**Ministerial Planning Referral: TPM-2014-37
2-12 Batmans Hill Drive (Tower 5 of the Collins Square Development Plan)**

11 November 2014

PLANNING REPORT

Application number:	TPM-2014-37
DTPLI Application number:	
Applicant / Owner / Architect:	Walker Corporation and Urbis / Victorian Urban Development Authority/ Woods Bagot
Address:	2-12 Batmans Hill Drive, DOCKLANDS VIC 3008
Proposal:	Development of a multi-storey commercial office building tower 5 (4E) with associated parking and amendment to the Collins Square Development Plan (Volume 4)
Date received by City of Melbourne:	5 September 2014
Responsible officer:	Julian Larkins
Report Date:	6 October 2014
(DM# 8777736)

Combined Plan - Level 01

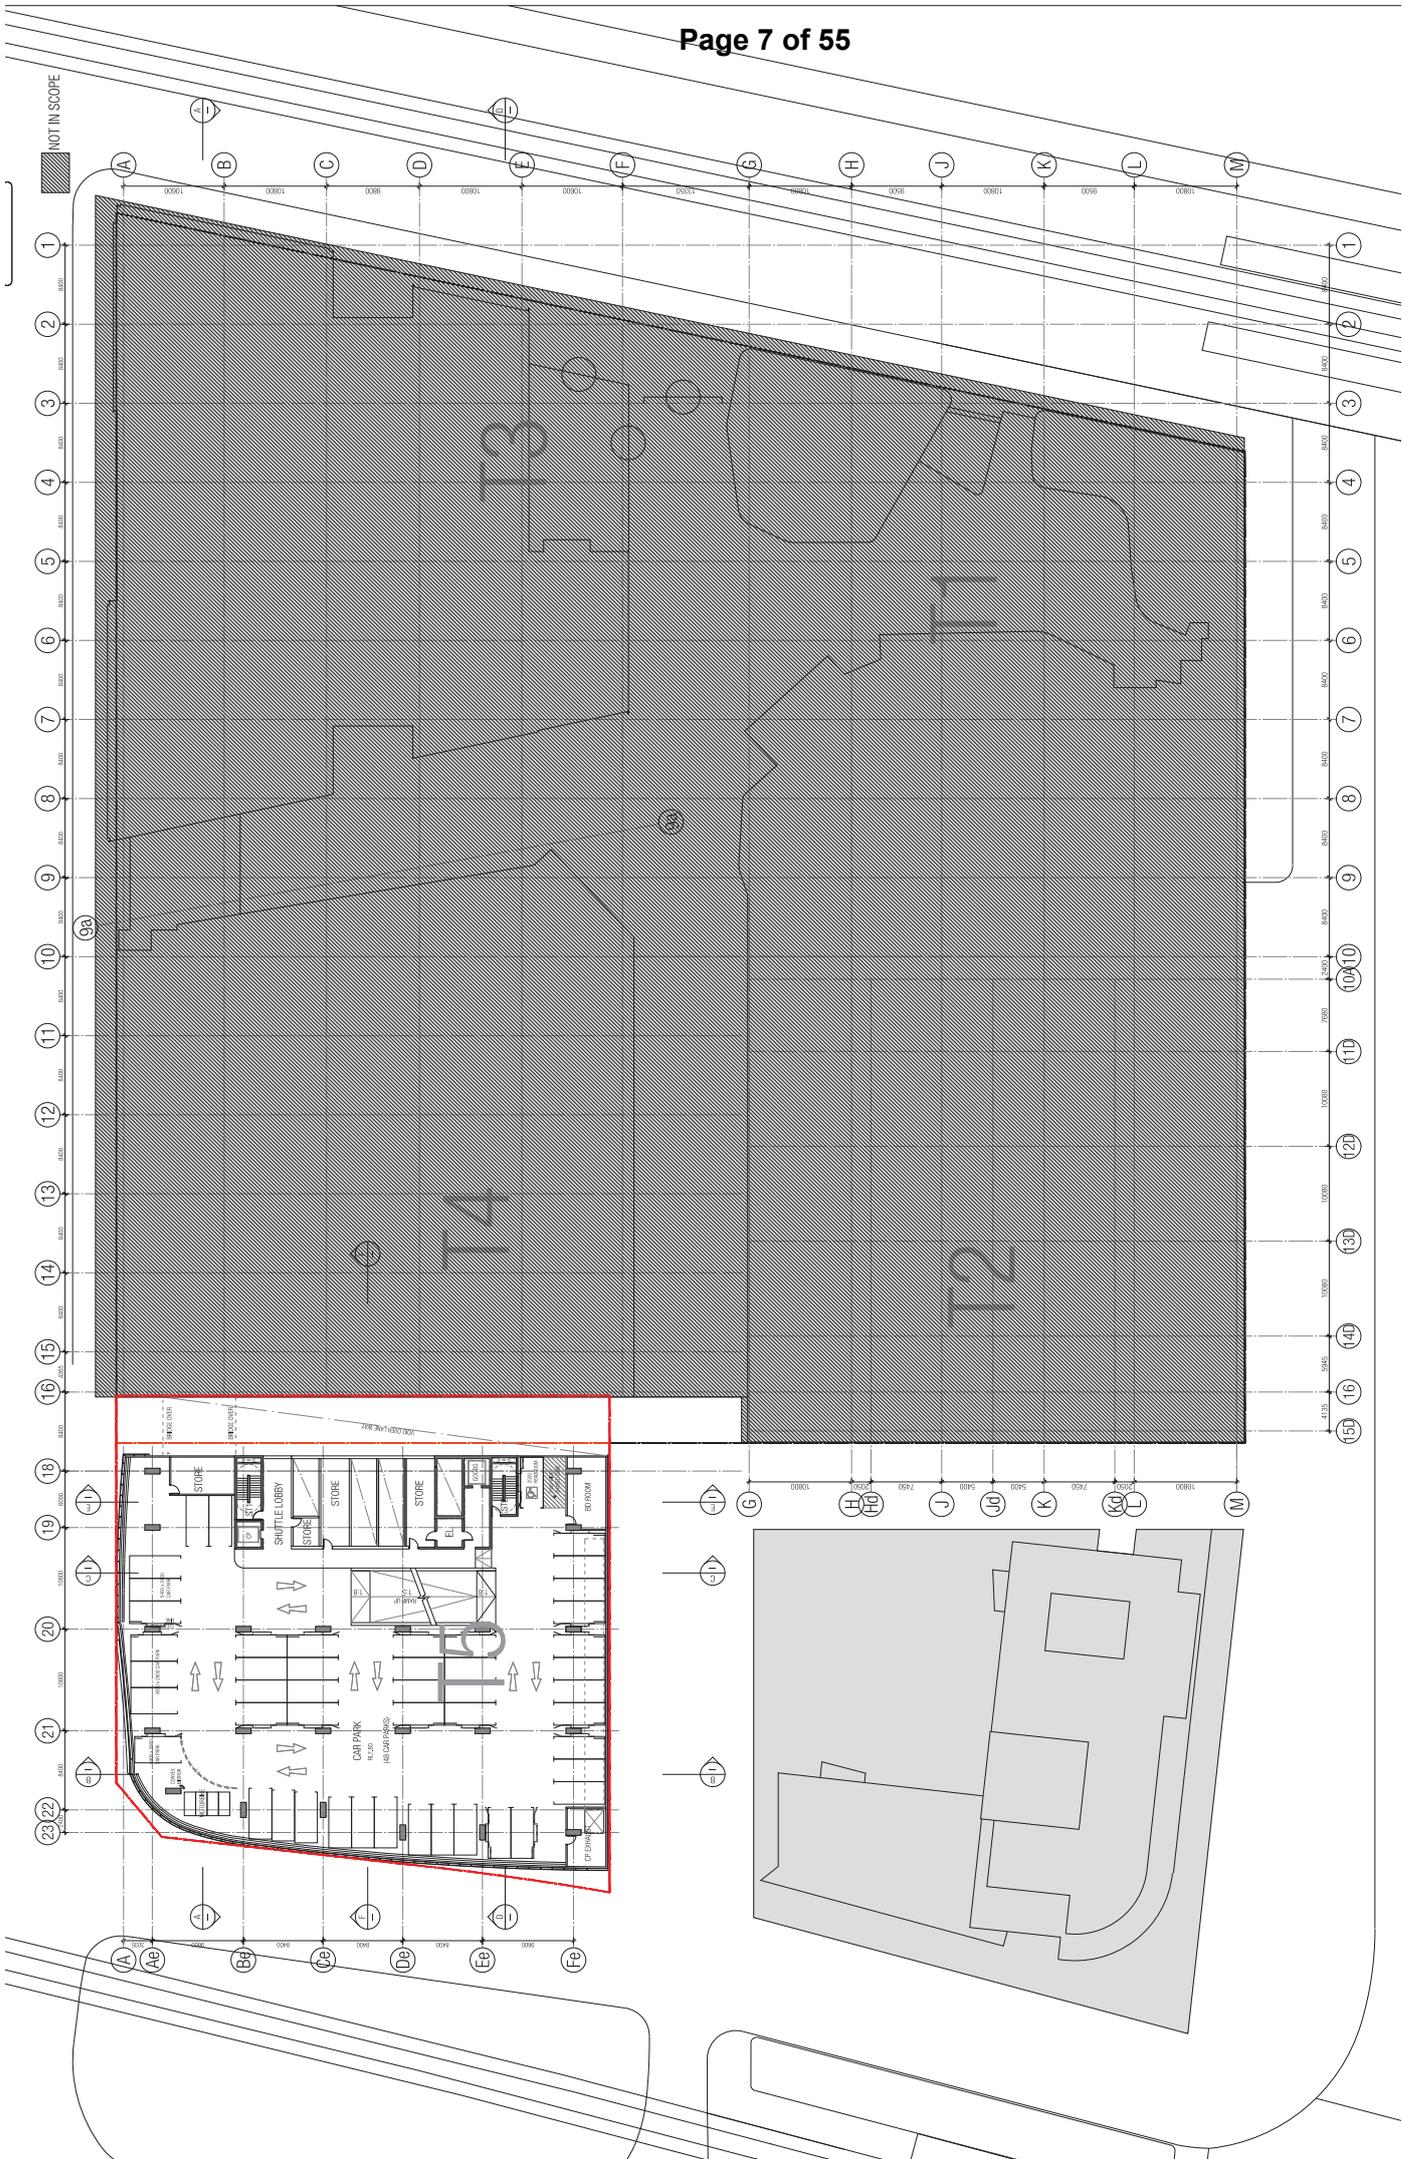
- this will involve loss of 8 car bays in T4 to allow for desired access between foyers Plan level RL 13.30, RL 16.05, RL 18.80, RL 22.75, RL 60.27 and RL 75.35 as above re. cutback floor plate between g/l 15D/16 and F/G
 - Ref. drawing TP3002E North Elevation shows a section through the arcade. Allowance must be made for daylight to be introduced between the setback parking 'bridge' link structure and the canopy structure.
4. The above matters should be included as conditions of permit.'

- cut back floor plate between grid lines 15D/16 and F/G
- cut back foyer area between g/l 16/18 and Fe/Ee
- this will involve loss of 8 car bays in T4 to allow for desired access between foyers Plan level RL 13.30, RL 16.05, RL 18.80, RL 22.75, RL 60.27 and RL 75.35 as above re. cutback floor plate between g/l 15D/16 and F/G
